LAKE PAHAGACO DAM

PHASE I INSPECTION REPORT

Lake Pahagaco Dam (NDS PA-874), Susquehanna River Basin, York County, Commonwealth of Pennsylvania. Phase I Inspection Report.

by BERGER ASSOCIATES, INC CONSULTING ENGINEERS HARRISBURG PA

SKETCH #1

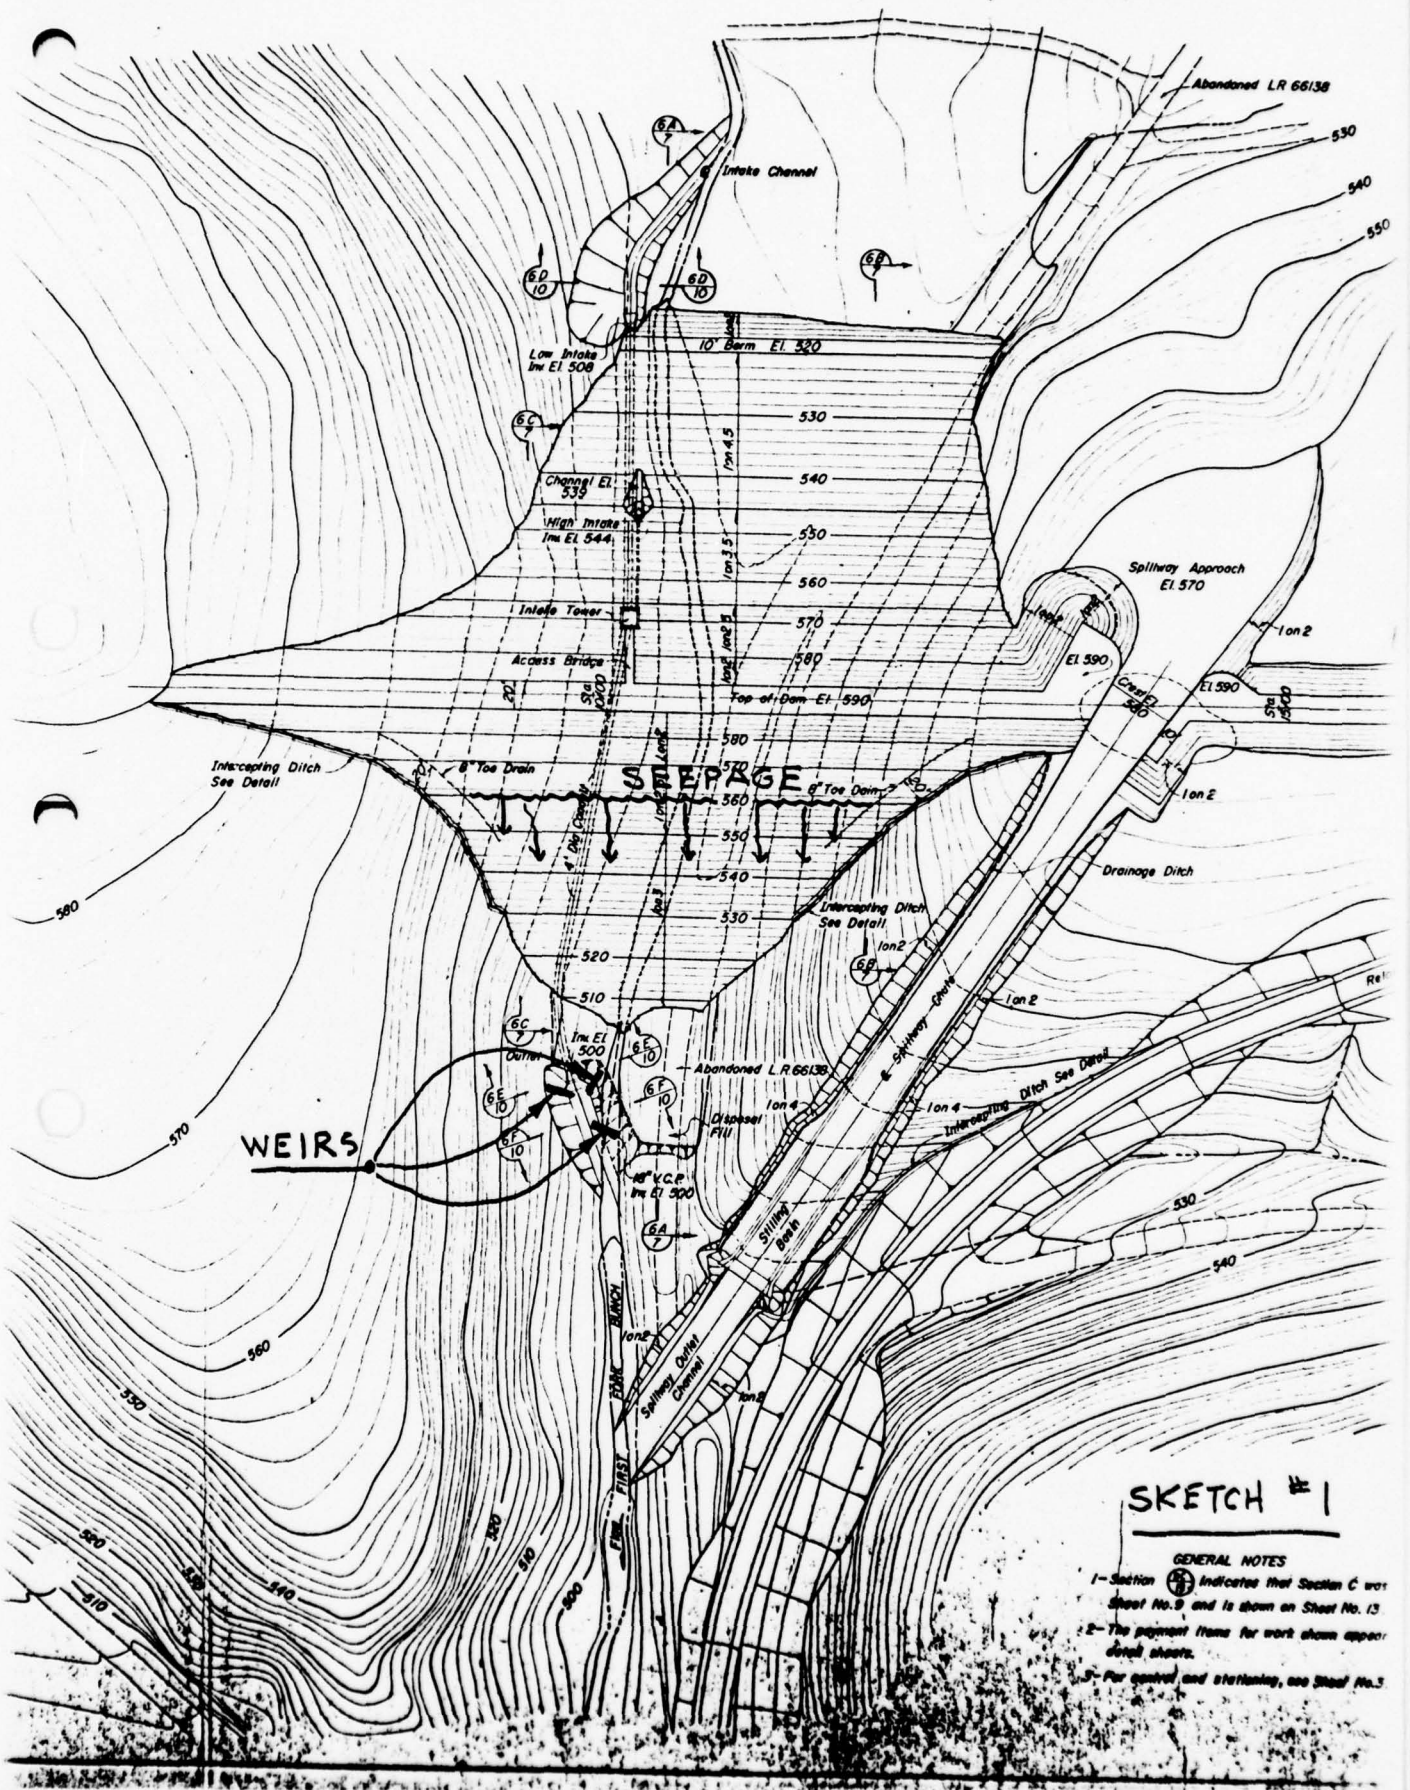
The dam is an earthfill dam with dumped riprap on the upstream slope. The downstream slope is covered with a heavy growth of tall grass, weeds, honeysuckle and some small trees. The presence of this growth on the downstream slope increased the difficulty to detect surface distress and seepage locations. Having prior knowledge of a seepage problem at the dam, emphasized the need to seek the source locations for the seepage. Exertion of firm pressure with one's foot on the surface mat was sufficient to detect the presence of water on the slope. The results of this inspection indicate a large area of seepage across the major portion of the downstream slope. Refer to Sketch 1 and 2, Appendix A for graphic location.

The main discharge pipe to the outlet structure is a 48-inch pipe which can be used as the emergency outlet for the dam. The outlet structure is a concrete impact basin with standard endwall and wings. Adjacent to each wing wall is a permanently installed concrete weir. The weirs were provided to measure the volume of seepage flow from and around the outlet structure (Refer to Sketch 1, Appendix A, for location of weirs).

PLATE VI

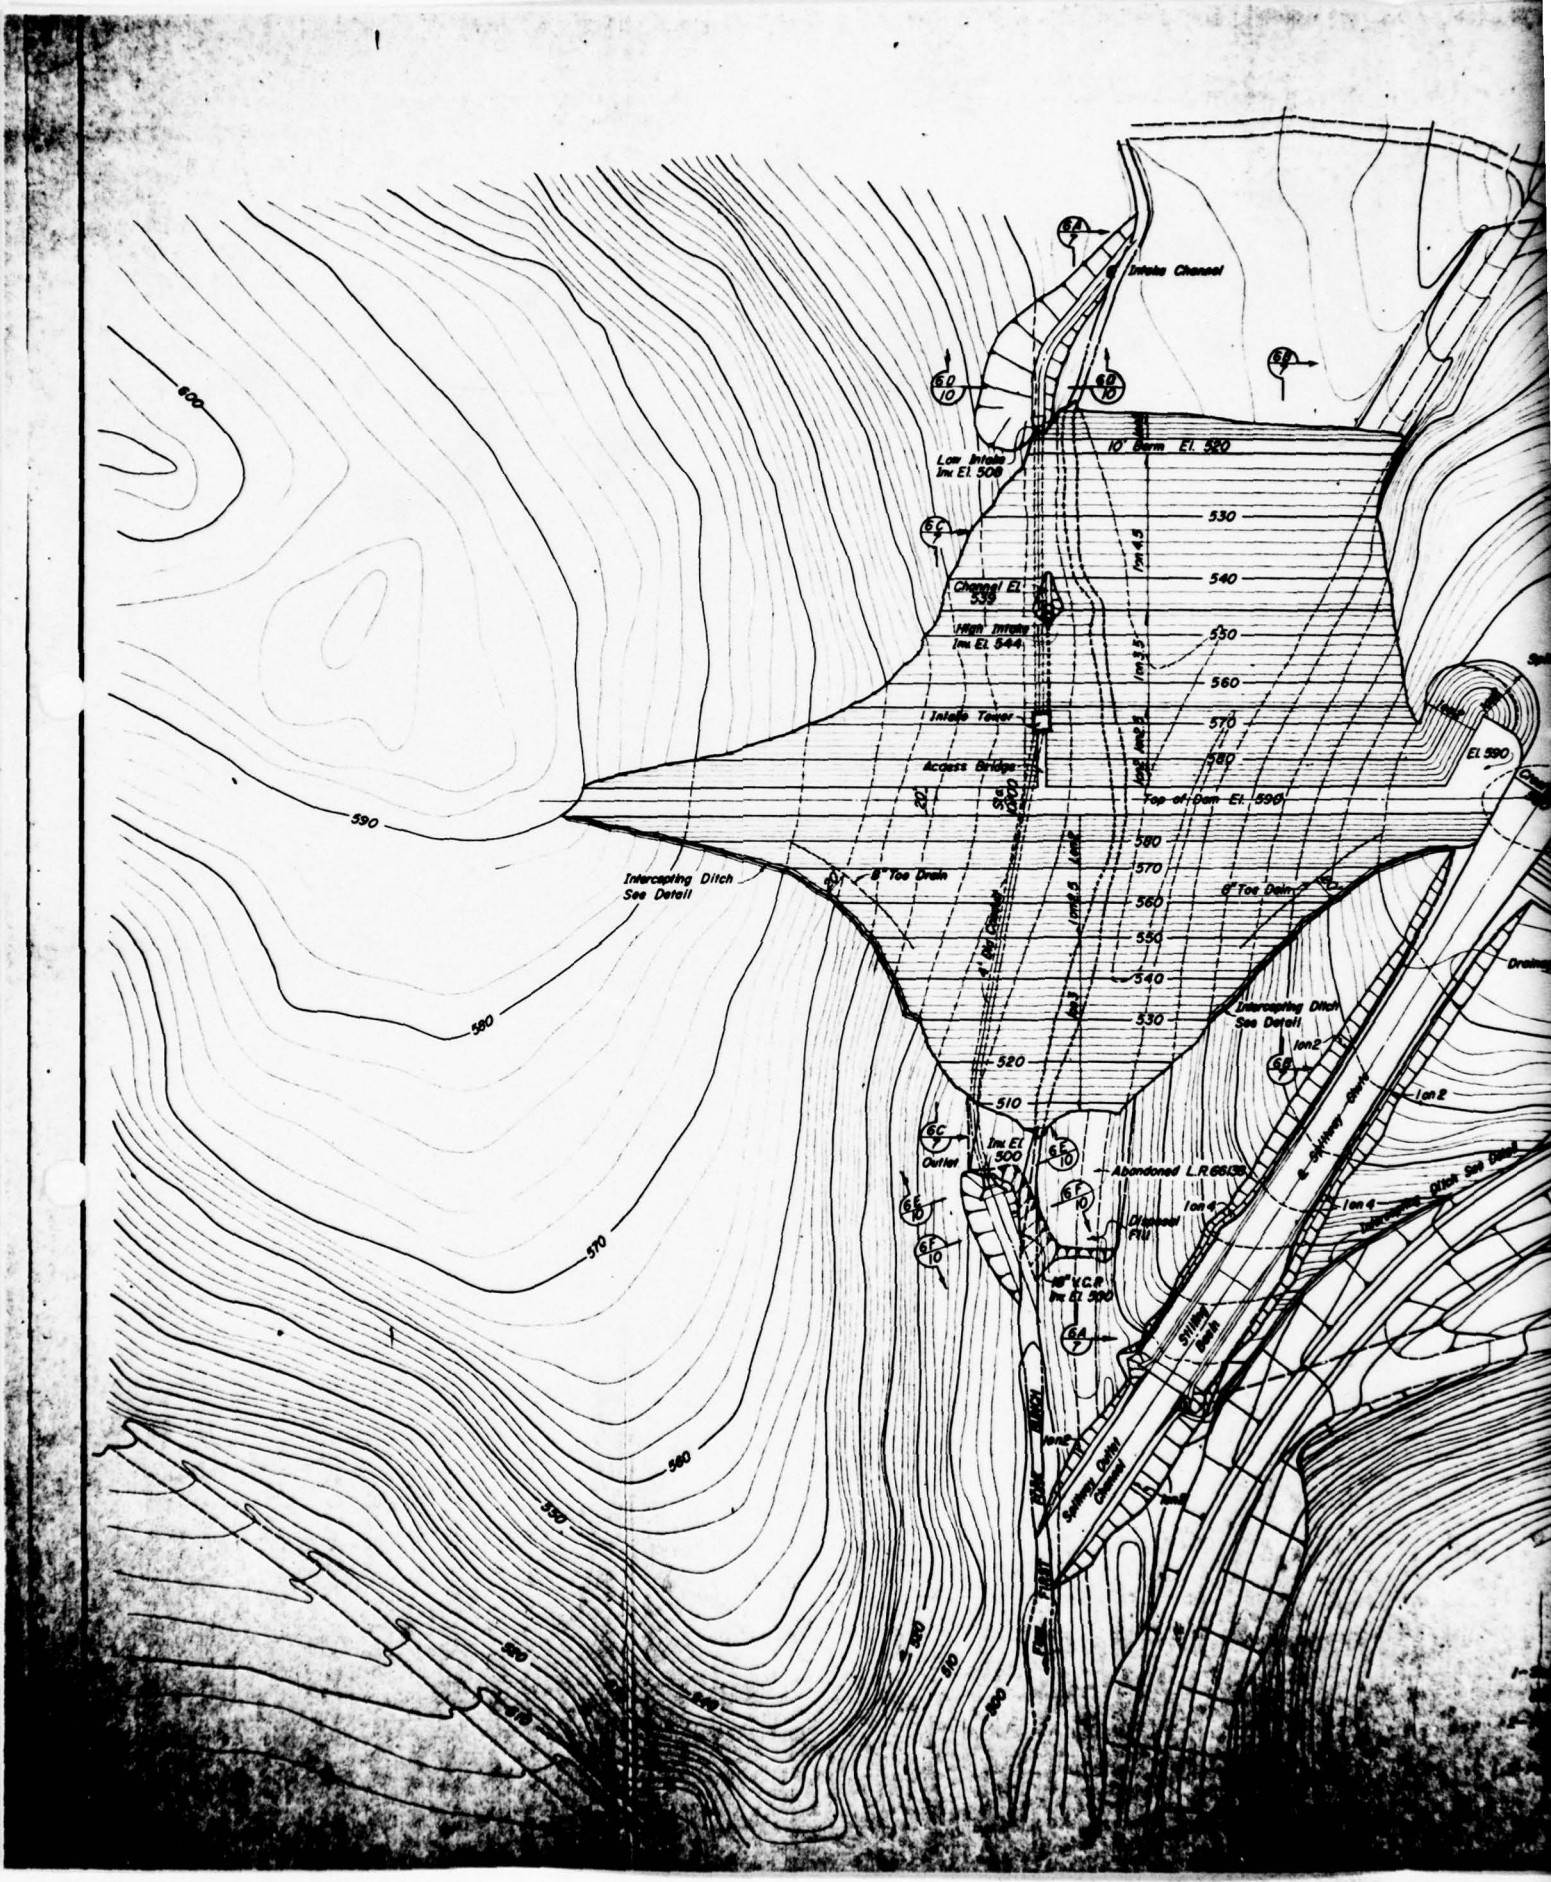
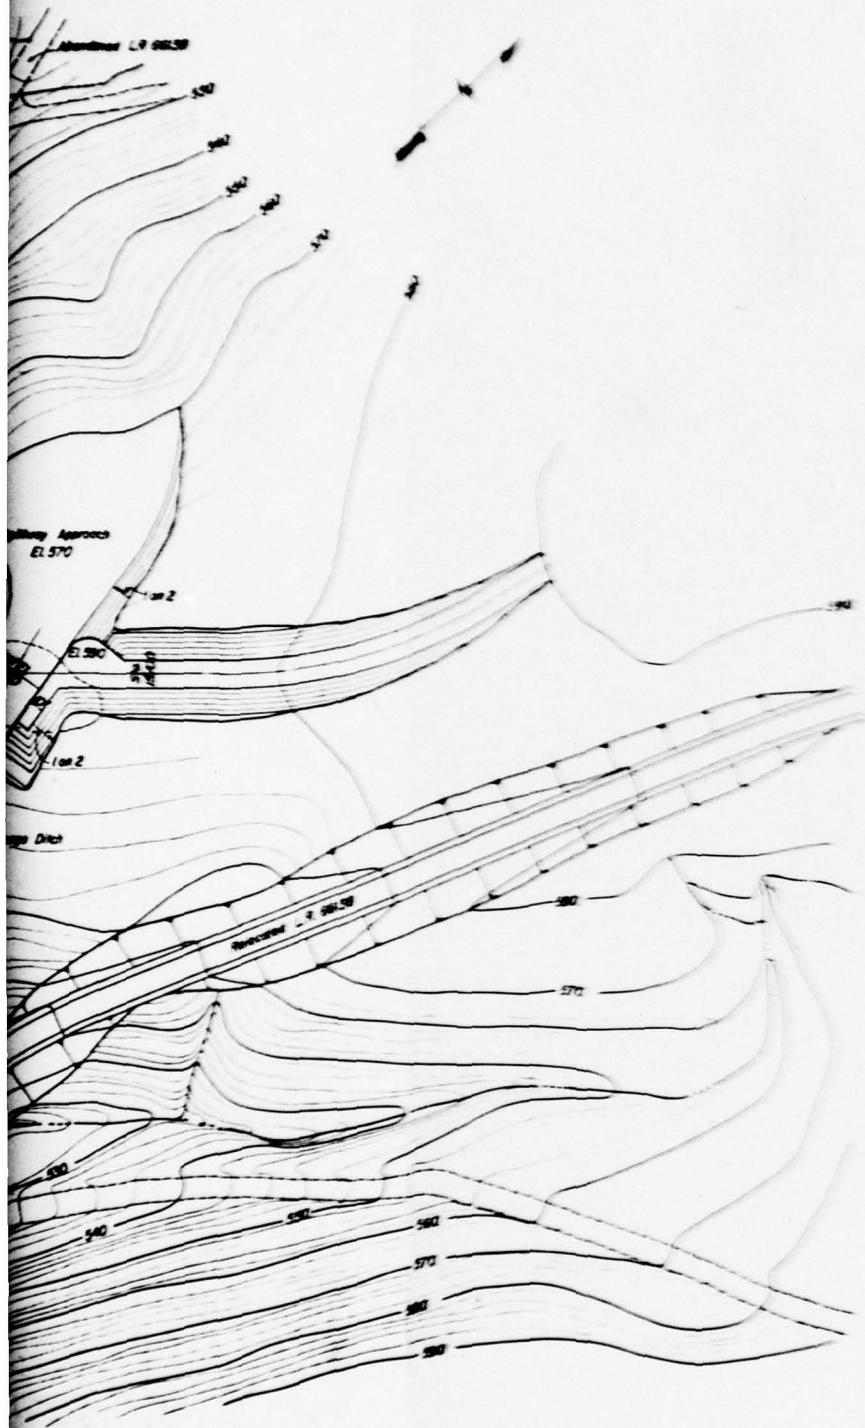
Vertical and horizontal alignment of the walls are good and the concrete surface is very good in all cases. Refer to Plate No. VI, Appendix D for drawings showing appurtenant structures and their relationship to the dam.

OUTLET DETAIL

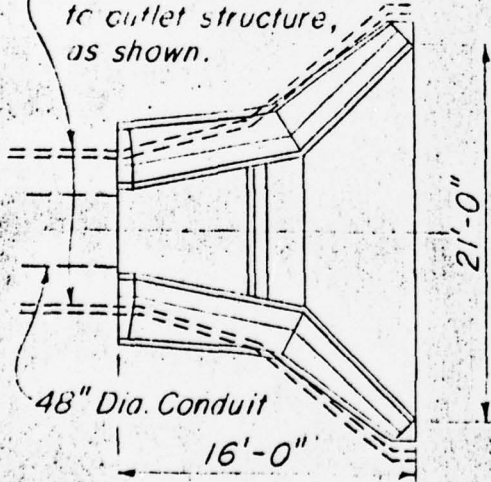
8" tile drain starts at a point 15' downstream from axis of dam and extends to outlet structure, as shown.
